AMENDMENTS TO THE DRAWINGS

REPLACEMENT SHEETS FOR FIGURES 1-21

ANNOTATED SHEET SHOWING CHANGES TO FIGURE 7

FIG. 7
(PRIOR ART)

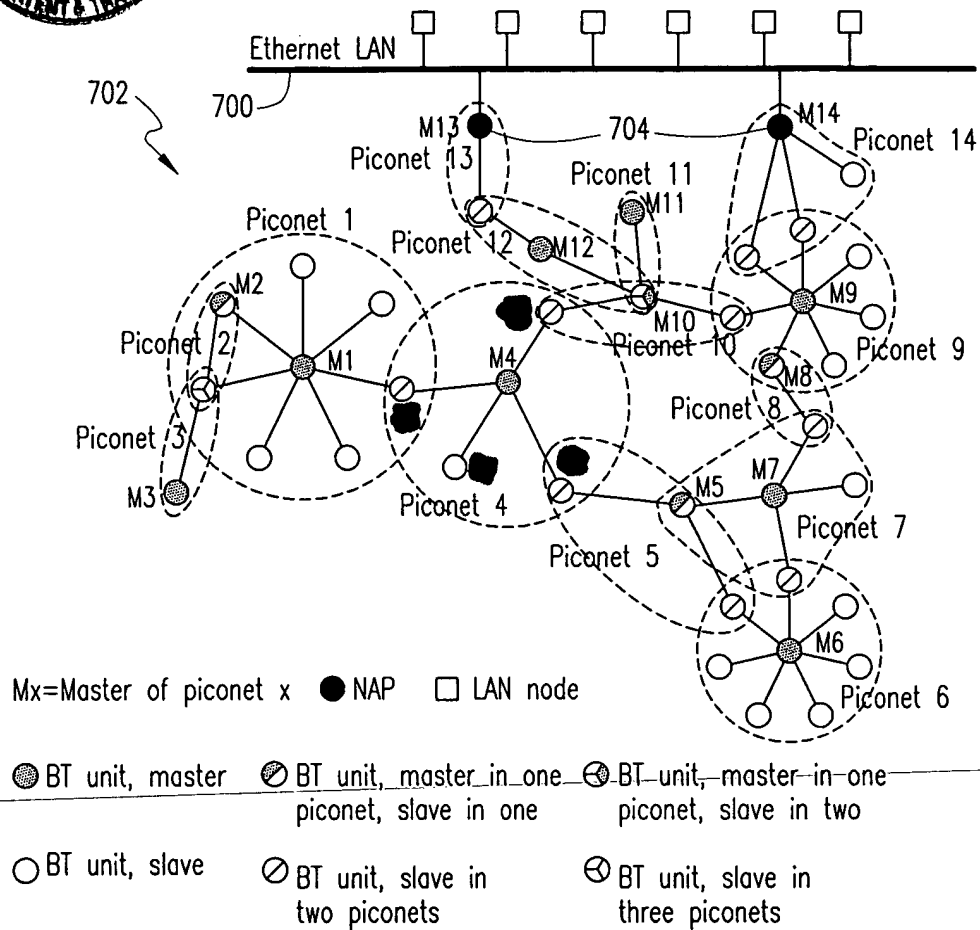
Figure 7 of the drawings is hereby amended to add the reference labels "S1," "S2," "S3," and "S4" to the four nodes directly connected to node "M4." Support for the amendment may be found in the specification in the paragraph bridging pages 31 and 32.
